Ref application number 2024/2563, 7 Blenkarne Road

Our family and live at the neighbouring property, 9 Blenkarne Road to the east of the proposed redevelopment at 7 Blenkarne Road. Ours is an owner-occupied family house where we have lived for 19 years.

Photo 1a

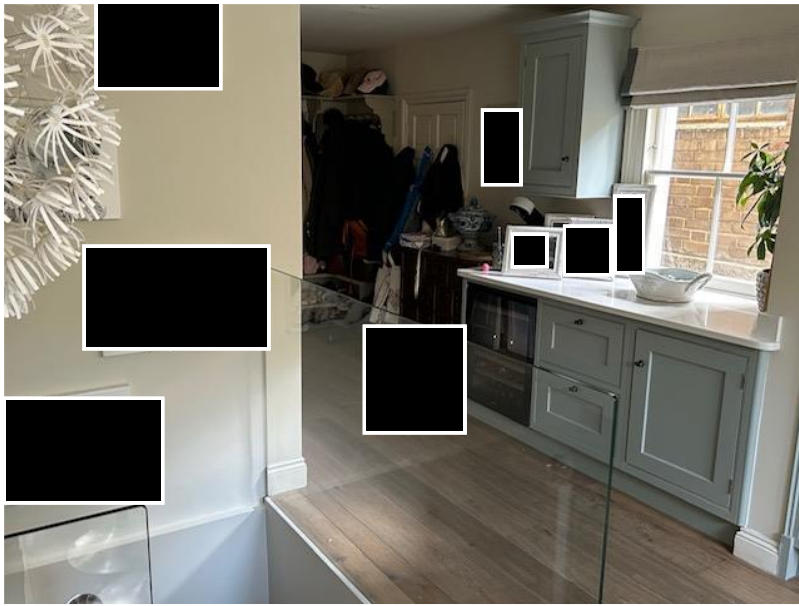
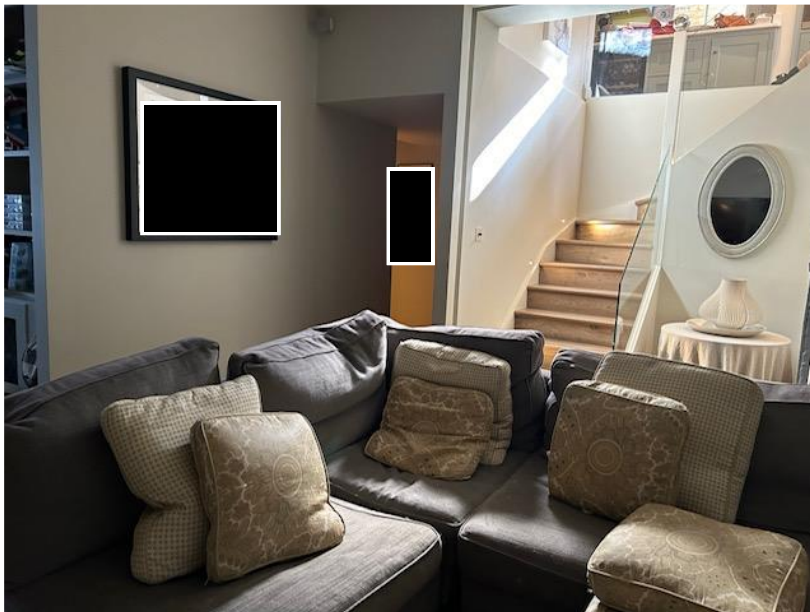
There is a ground floor kitchen window on the west side of the house. It is the only window on the west-side of the ground floor which provides valuable light to this end of the kitchen (photo 1a, 1b). Crucially, it also provides light to the core living-space in the basement through a glass staircase specifically designed for this purpose (photo 1c). This would not have been apparent to the applicant's light consultant without a site visit which was never requested.

You can clearly see in the photos below that this window provides substantial light into this end of the kitchen and into the basement sitting room. This window would be entirely blocked and very substantially darker as a result of the proposed new, higher, longer boundary wall.

Photo 2a

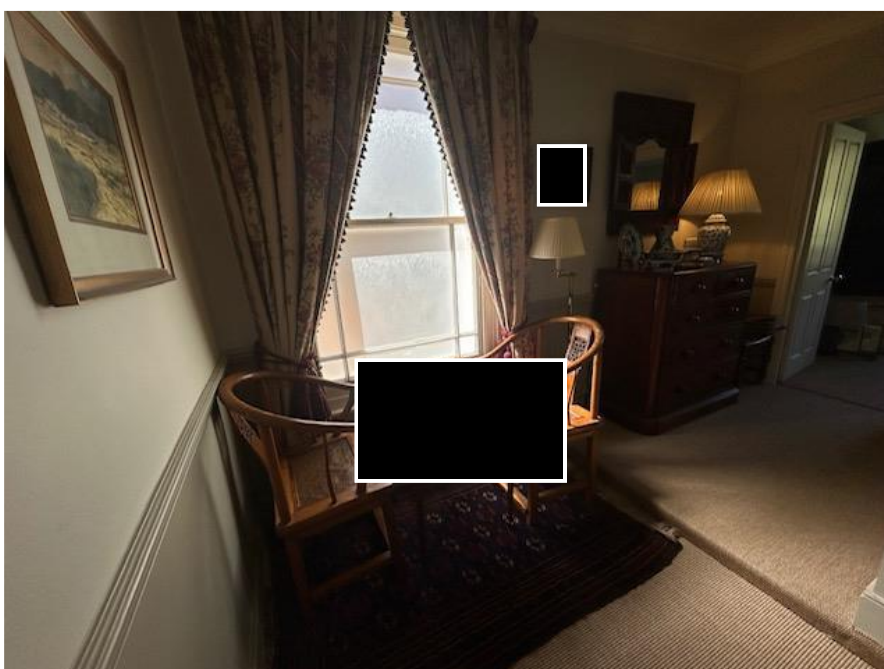
This first floor window would be almost completely blocked by the new boundary wall 80cms away (see photo 2a). This window leads on to 8sqm of clearly “habitable” living space (where my son and I play chess, as it happens!). Again, without a site visit the applicants’ light surveyor might not have been aware of the size or use of this space. The modelling needs to be updated to consider this window and to take account of the loss of light to core circulation space of the house which, whilst we acknowledge is more secondary, further reflects the loss of amenity given the significant obstruction to this window. We also believe this space has legal rights of light protection.

Photo 3a

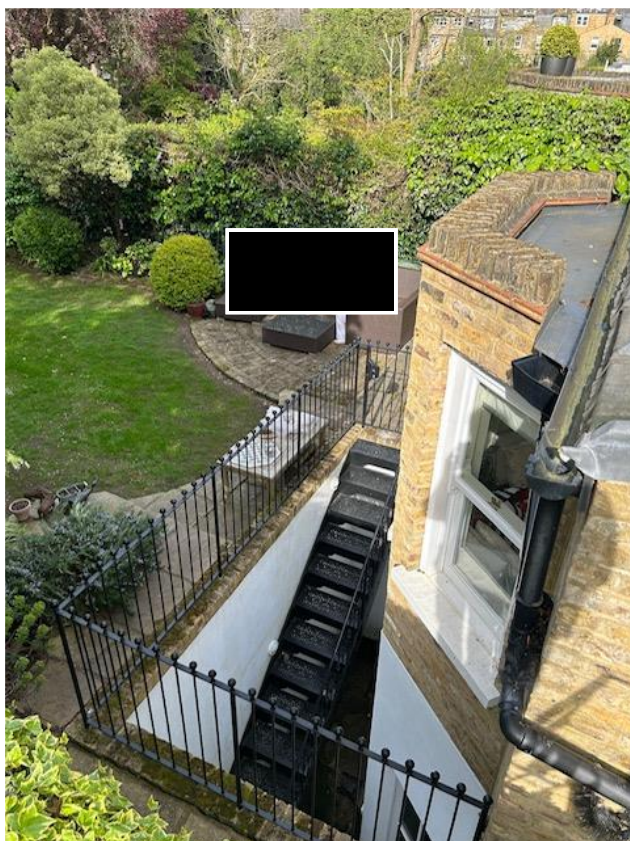
We have serious privacy concerns about this proposed terrace. The architect kindly allowed us access to the garden to see this and the photograph below was taken from the proposed location of the north-east corner of this terrace, at the border of 9 Blenkarne Road.

- a) that someone standing at or near this corner (or standing along the length of the balcony, so this view would not be prevented by just a screen at the east end) looks into a seating area in our garden that was previously quite private, as well as into a kitchen bay window and the rest of the garden;
- b) you can see the photographer’s shadow on our kitchen bay window demonstrating that any kind of eye-height screening to prevent overlooking will reduce the light into both this kitchen window and the lightwell that provides much-needed light to this basement living room. We would note that any such privacy screening has not been taken into account in the submitted lighting assessment but, notwithstanding this, any such screening will have an overbearing impact on us and our home.

Figure 6a

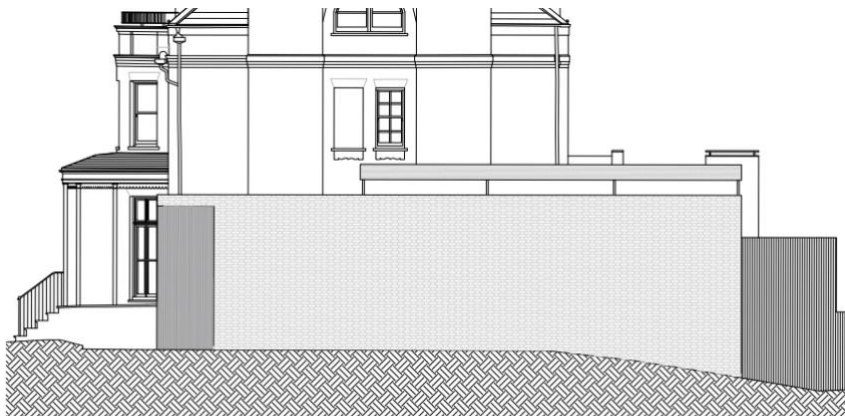
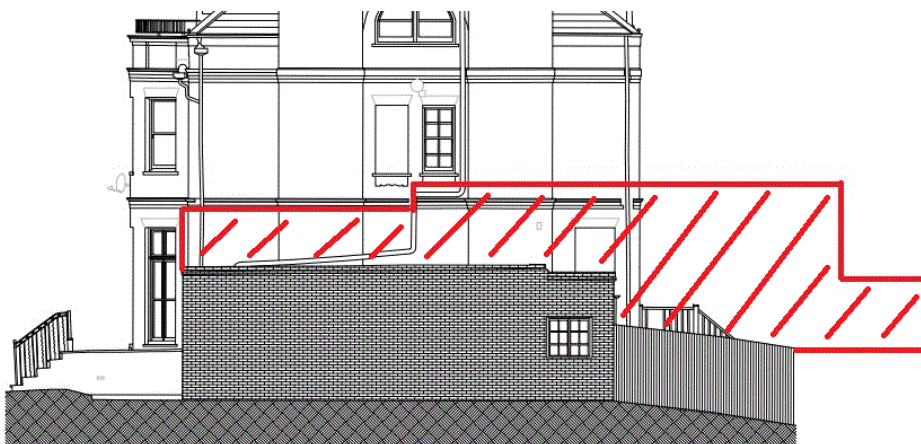
We don't think the overall design, with an excess of glass to the rear and particularly the very large new boundary wall, are in keeping with the area. As noted above, the east boundary wall will almost double in size – from 10m x 4m to 15m x 4.9m and as one, huge slab of bricks is not seen elsewhere in the area. We hope the heritage officer will understand the bulk of what is being proposed and, again, we would welcome him/her for a site visit.

Photo 7a

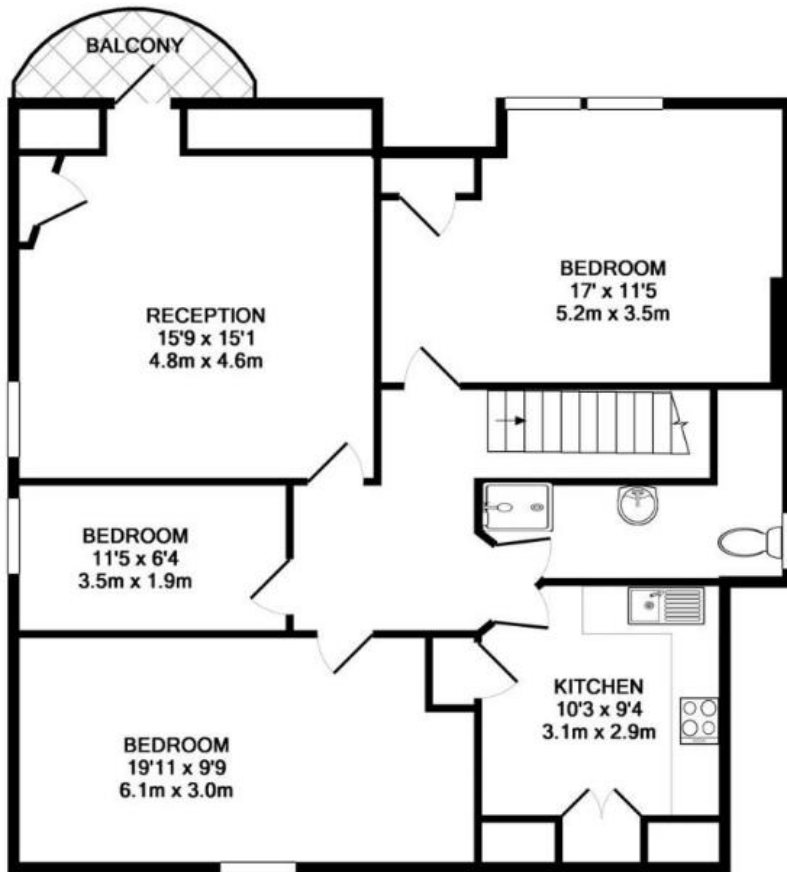
The current top floor flat has 5 rooms and a bathroom with a pleasant aspect and windows that face north, south, east and west. It was previously used as a 3-bedroom flat and is described online (Rightmove etc, photos and floorplans 7a below) as such.

The top floor flat is clearly a family-sized dwelling which up until recently had 3-bedrooms, a reception room, kitchen and bathroom.. The proposed replacement is a 2-bedroom basement flat with 2 deep lightwells and no aspect. This conflicts with WLP LP25.
